**Bureau of Alcohol, Tobacco,  
Firearms and Explosives**

907020:MRC  
3311/302558

907010: RKD  
3311/303845

This is in reference to your submission and accompanying correspondence to, Bureau of Alcohol, Tobacco, Firearms and Explosives (ATF), Firearms Technology Industry Services Branch (FTISB), which is accompanied by two AR-15 type rifles equipped with what is described as LV-15 Trigger Reset Devices (see enclosed photos).

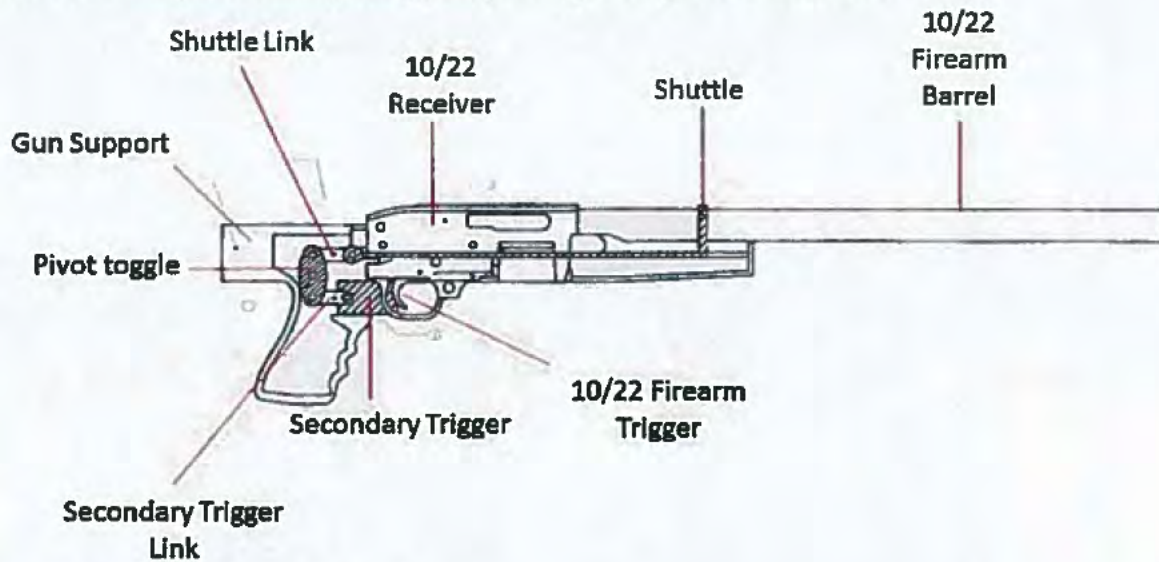
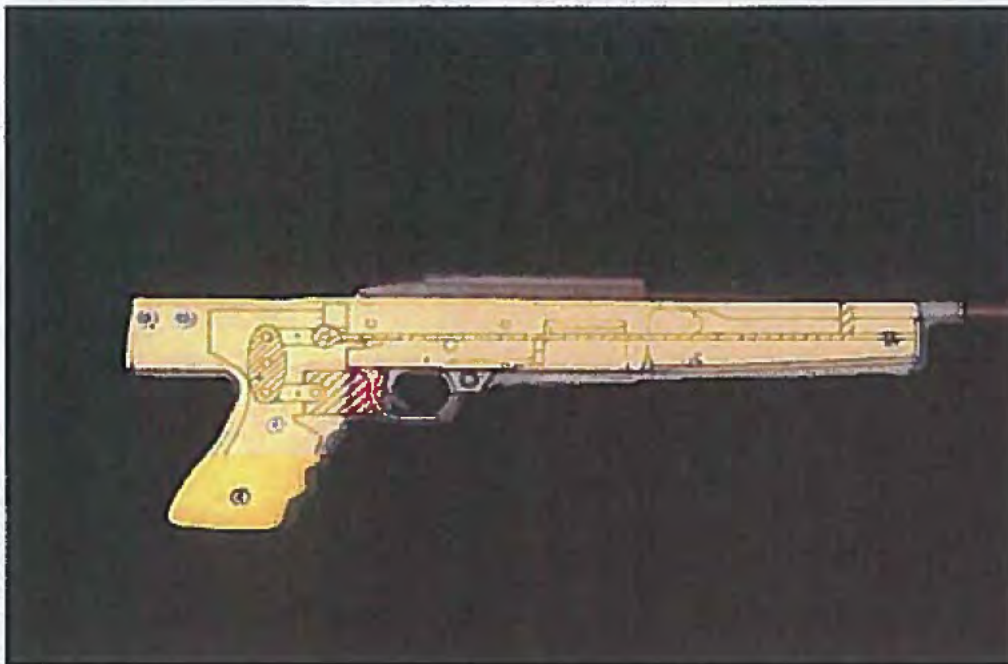
The internal components comprising your prototype design are shown here:

You provided the prototype shown here:

The internal components are shown here as they would exist inside the prototype.

Upon review, we find that your prototype permits a shooter to fire automatically, more than one shot, without manual reloading, by a single function of the trigger. Your design utilizes recoil energy to move the shooter's finger and permits the firearm to reset. However, your prototype actually utilizes the single pull of the trigger to accomplish this. In this way, the prototype design uses a single

Based on our evaluation and provisions of Federal law cited above, FTISB concludes that the prototype design is a combination of parts designed and intended for use in converting a weapon into a machinegun. It is therefore a "machinegun" as defined in the above-cited § 5845(b).

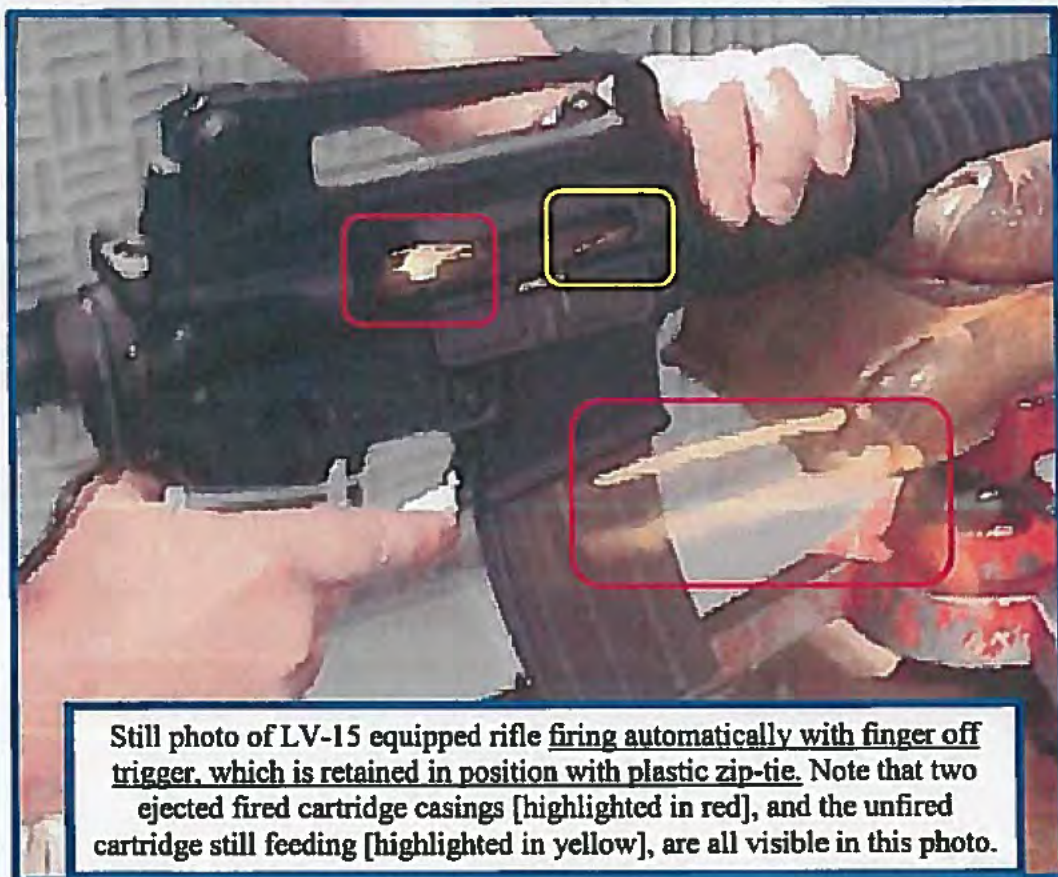
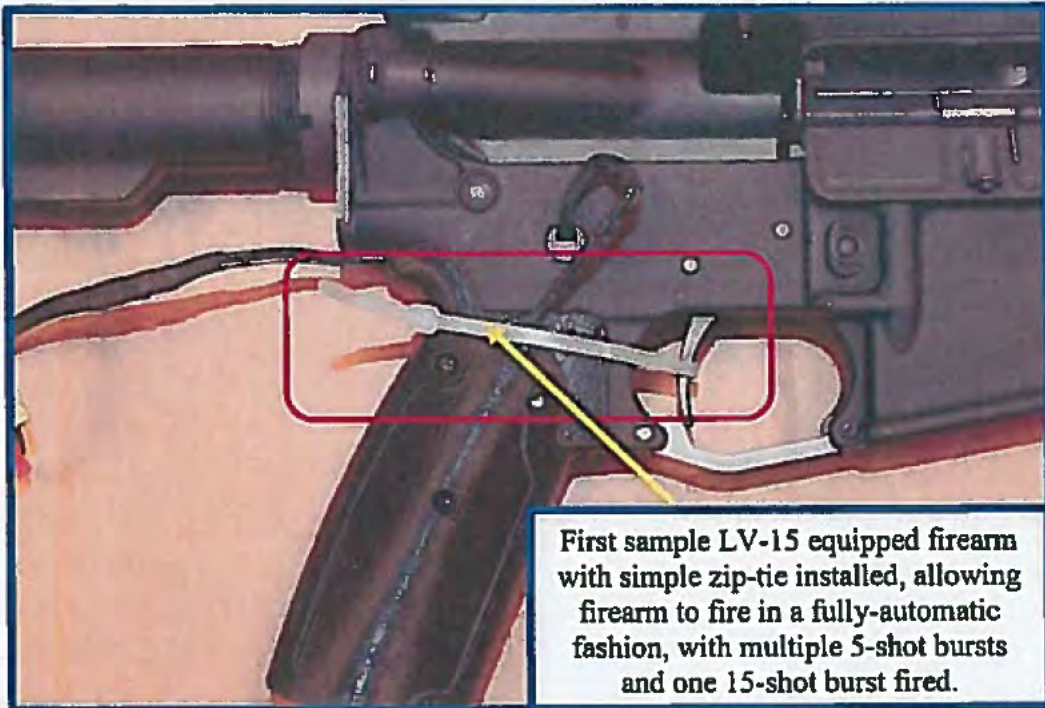
When the trigger was pulled slowly and retained in a position at which the hammer was just release with the device actuated during manual field testing, a condition resembling automatic cycling was observed on several occasions, during field testing of the LV-15 equipped firearm. Actual test firing with live ammunition replicated this same condition.

FTISB testing with the trigger of the LV-15 equipped firearm pictured on the previous page, retained in the static position shown with a plastic zip-tie, revealed that the LV-15 device could allow a semiautomatic AR-15 type firearm to fire automatically more than one shot, without manual reloading, by a single function of the trigger.

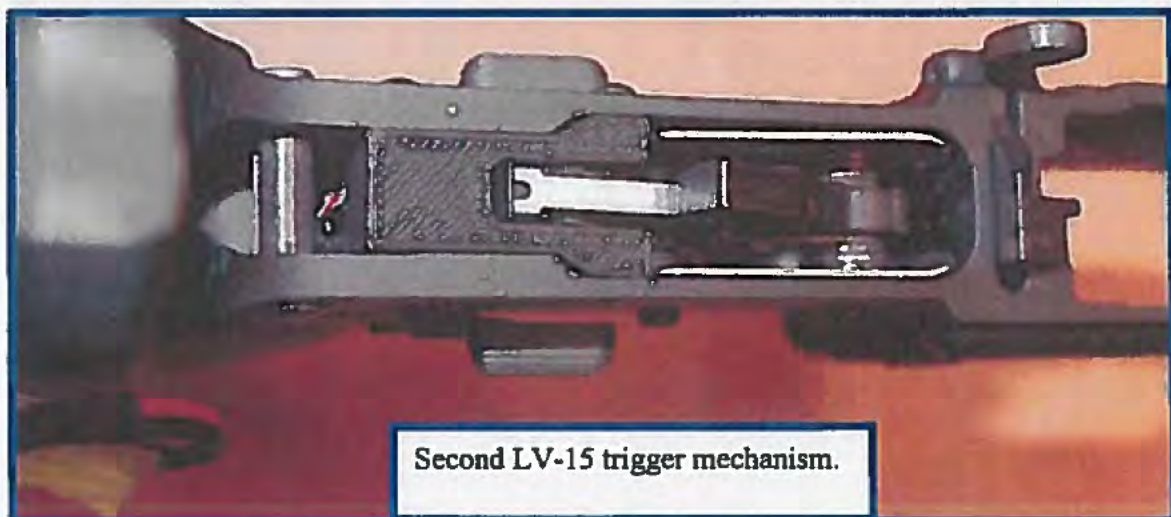
FTISB next proceeded with an examination of the second LV-15 equipped firearm, which was submitted on April 6, 2016. This second prototype is described as being functionally identical to the previous model pictured above, featuring *"small improvements that have come as the result of further development since the original submission."* The LV-15 device equipped rifle initially manually field tested and appeared to operate similarly to the first version of the LV-15 examined. Shortly after testing began, the LV-15 device ceased operating. Both recharging the original battery and substituting a different recharged battery failed to return the device to operational status. Due to the aforementioned deficiency, FTISB personnel terminated testing of the submitted device.

Although testing of the second device could not be completed because of the malfunction, it is designed, and operates, in the same way as the first submitted device. As a result of the subject test weapon firing more than one shot, without manual reloading, by a single function of the trigger with the submitted device installed, the submitted LV-15 devices are classified as a combination of parts designed and intended, solely and exclusively, for use in converting a weapon into a machinegun and thus a "**machinegun**" as defined in 26 U.S.C. § 5845(b). This classification is based on an evaluation of the item as submitted and that the item converts a weapon to fire automatically, regardless of how reliably it shoots automatically more than one shot, without manual reloading, by a single function of the trigger.

*Photo 2 obtained from customer supplied video of rifle utilizing CMMG .22LR conversion device.*

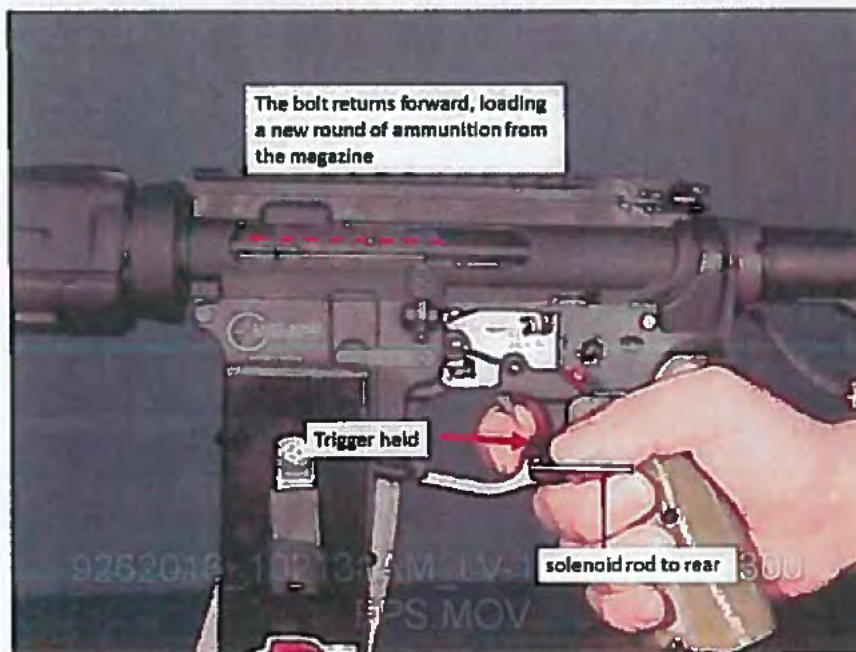
To initiate firing using the LV-15, a shooter must simply pull the trigger (photo 1—note that the solenoid rod is inside the firearm. These photos show the approximate location of the rod in the firearm. This is done simply to explain the functioning of the device). After firing, and when the bolt has loaded a second round of ammunition (photo 2-3), the mechanical-electrical operation of the LV-15 trigger device utilizes a “solenoid rod” to push the trigger forward as if the shooter had released the trigger (photo 4). Although the trigger is pushed forward the shooter never releases the trigger. Pursuant to your explanation, the shooter must merely maintain a pull that exerts “not more than 12 pounds of force during said 15 millisecond interval.” If the shooter maintains this pressure, a second shot is fired (photo 5). As stated above, firing requires so little input from the shooter—a single pull with constant pressure—that a zip tie can effectively fire a weapon utilizing the LV-15 until the ammunition source is exhausted. A shooter need only pull the trigger once to initiate firing, and the LV-15 then operates automatically to continue firing.
